1. EXISTING CONDITIONS PLAN OF THE VILLAGE DRIVE TOWNHOMES, LOT 1, STEAMBOAT SPRINGS, COLORADO, VILLAGE DRIVE.
2. CIVIL CONSTRUCTION PLANS COMPLETED BY LANDMARK CONSULTANTS, INC. IN 2022.
3. THIS PLAN IS FOR VARIANCE AND DEVELOPMENT PLAN TO REMOVE THE APPROVED ENTRANCES AND STAIRS TO VILLAGE DRIVE.
4. THE PLAN IS BASED ON FIELD SURVEYING COMPLETED MAY 2024 AND MARCH 2025.

EASEMENT EXHIBIT
OF A REPLAT LOT 1, VILLAGE DRIVE TOWNHOMES
LOCATED IN THE SW ¼ OF SECTION 27, TOWNSHIP 6 NORTH, RANGE 84
WEST OF THE 6TH P.M., STEAMBOAT SPRINGS, ROUTT COUNTY,
COLORADO

SITE PLAN &
REVISION
EXHIBIT

**LOT 1
VILLAGE DRIVE
SUBDIVISION**

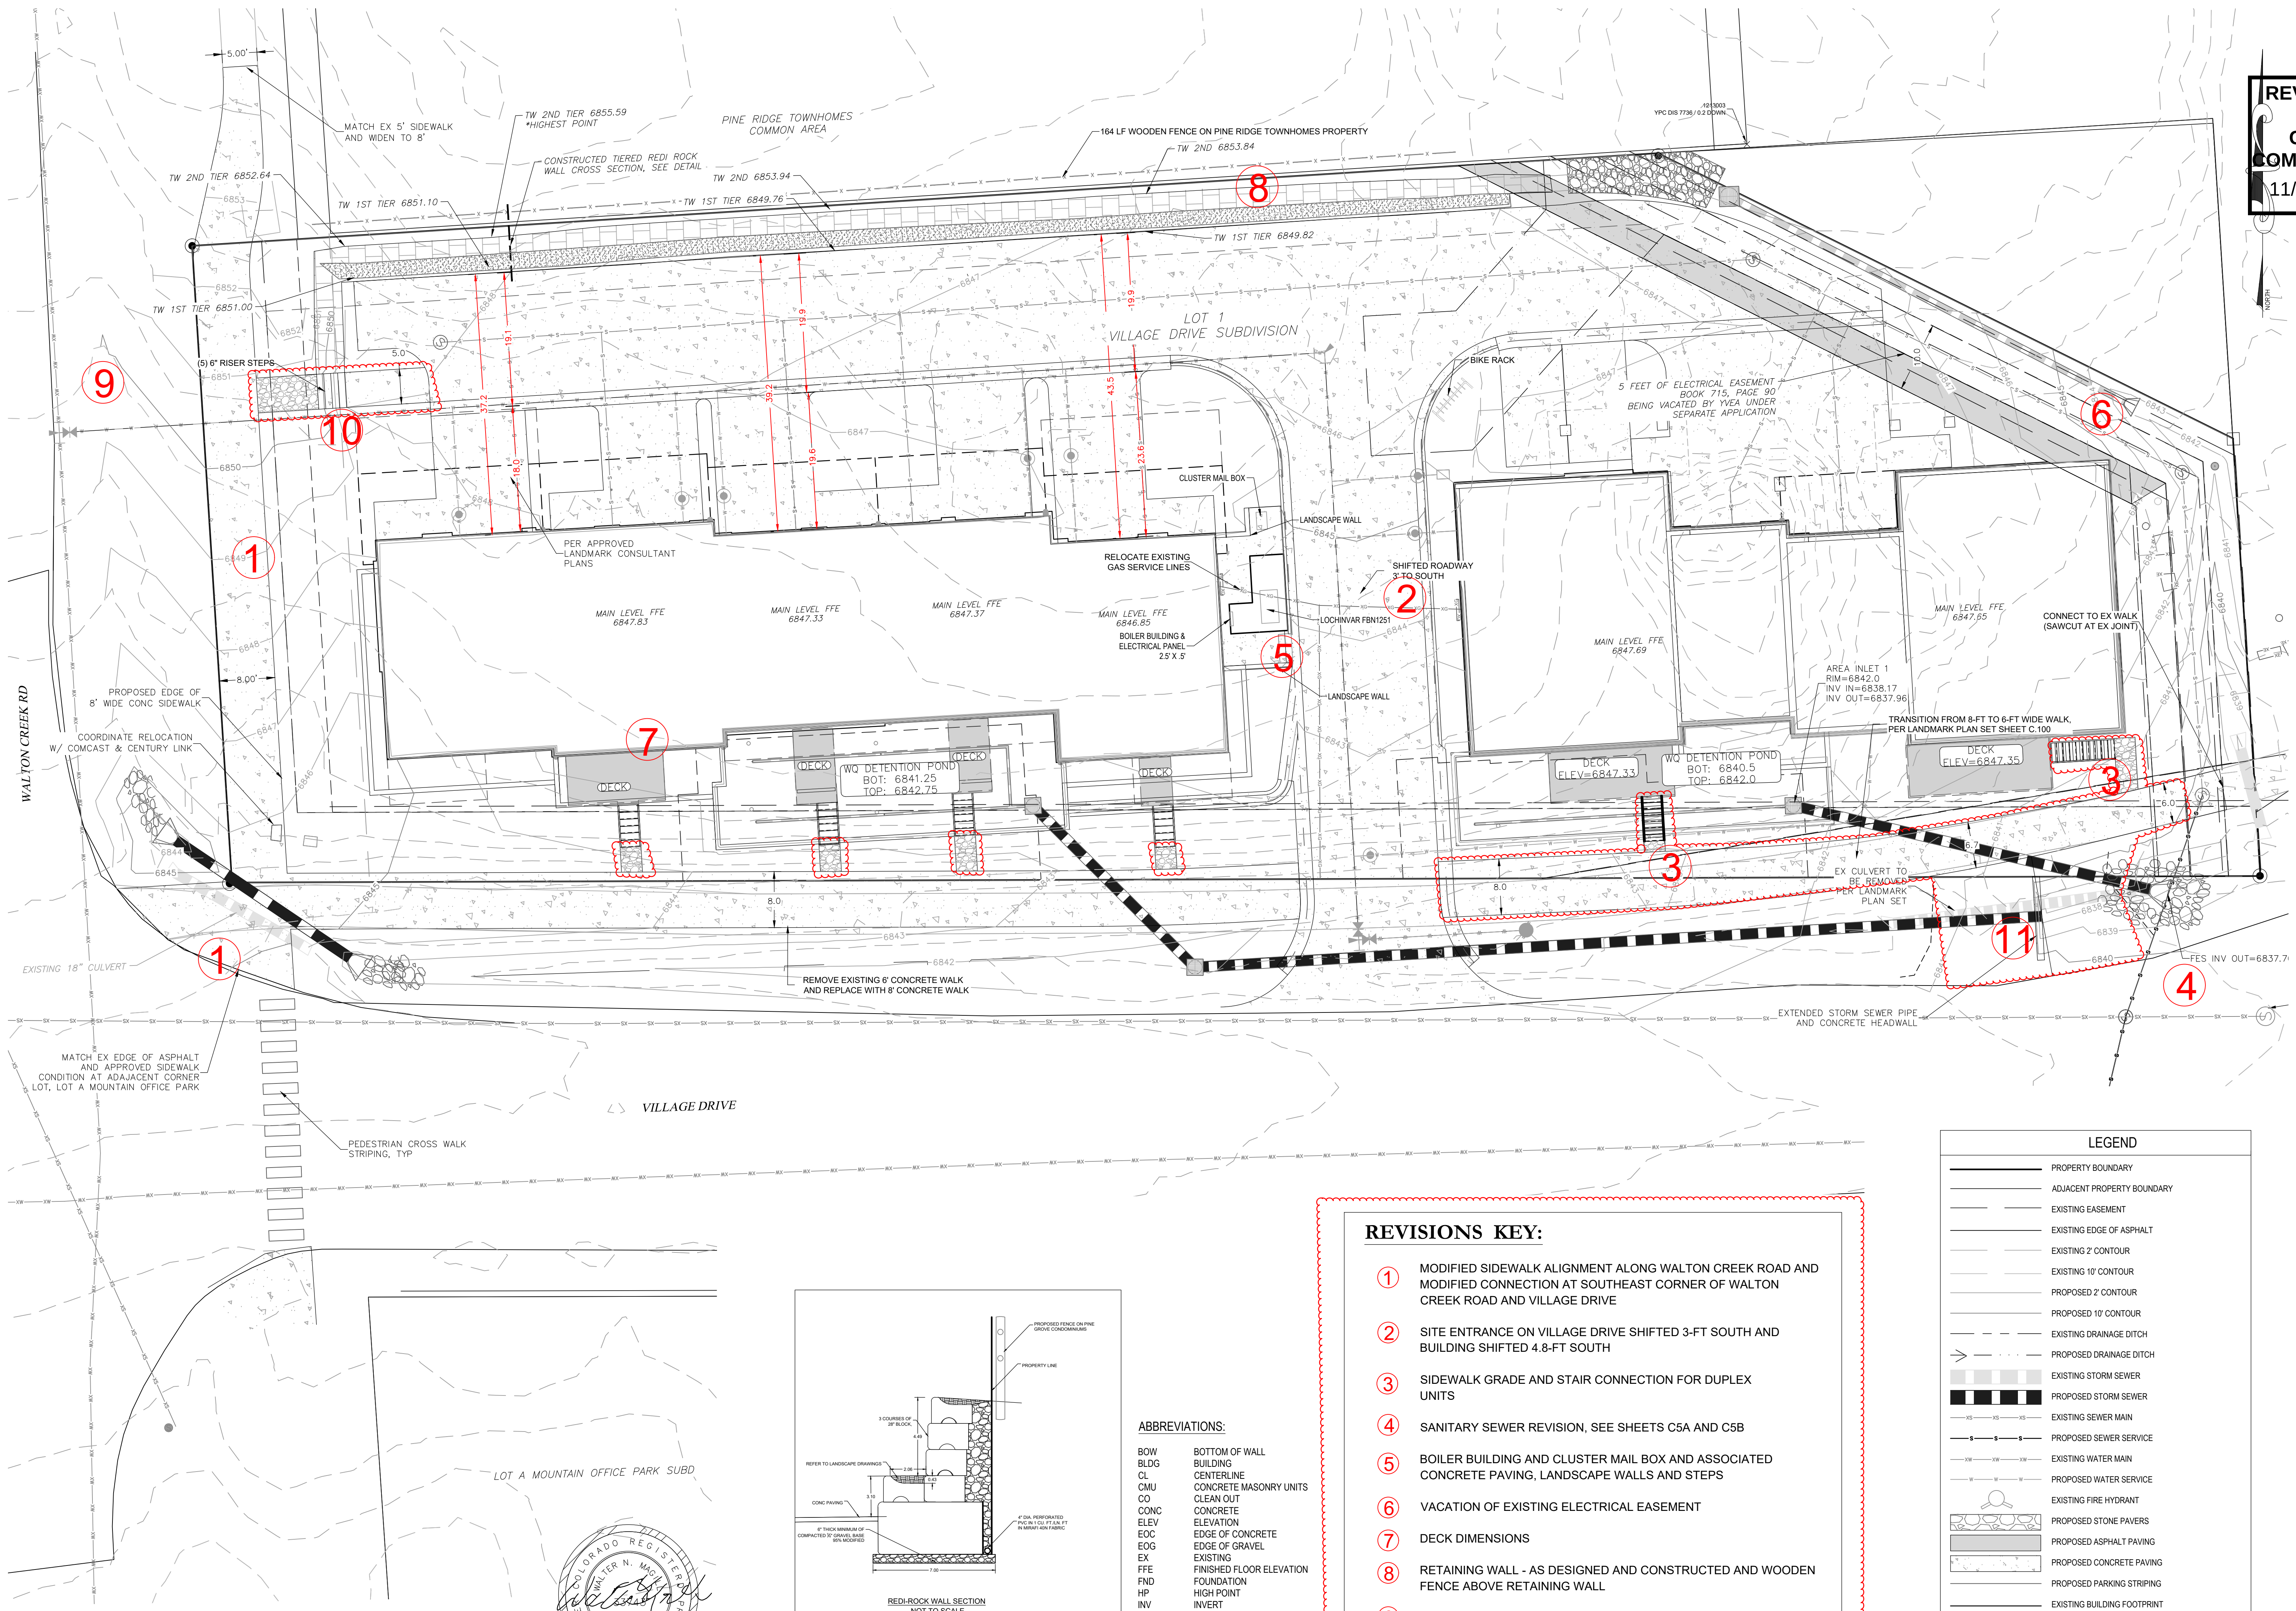
- MODIFIED SIDEWALK ALIGNMENT ALONG WALTON CREEK ROAD AND MODIFIED CONNECTION AT SOUTHEAST CORNER OF WALTON CREEK ROAD AND VILLAGE DRIVE
- SITE ENTRANCE ON VILLAGE DRIVE SHIFTED 3-FT SOUTH AND BUILDING SHIFTED 4.8-FT SOUTH
- SIDEWALK GRADE AND STAIR CONNECTION FOR DUPLEX UNITS
- SANITARY SEWER REVISION, SEE SHEETS C5A AND C5B
- BOILER BUILDING AND CLUSTER MAIL BOX AND ASSOCIATED CONCRETE PAVING, LANDSCAPE WALLS AND STEPS
- VACATION OF EXISTING ELECTRICAL EASEMENT
- DECK DIMENSIONS
- RETAINING WALL - AS DESIGNED AND CONSTRUCTED AND WOODEN FENCE ABOVE RETAINING WALL
- WATER LINE REVISION, SEE SHEET C6
- STAIR CONNECTION WITH WALTON CREEK SIDEWALK
- CONCRETE HEADWALL ON EXTENDED STORM SEWER OUTFALL
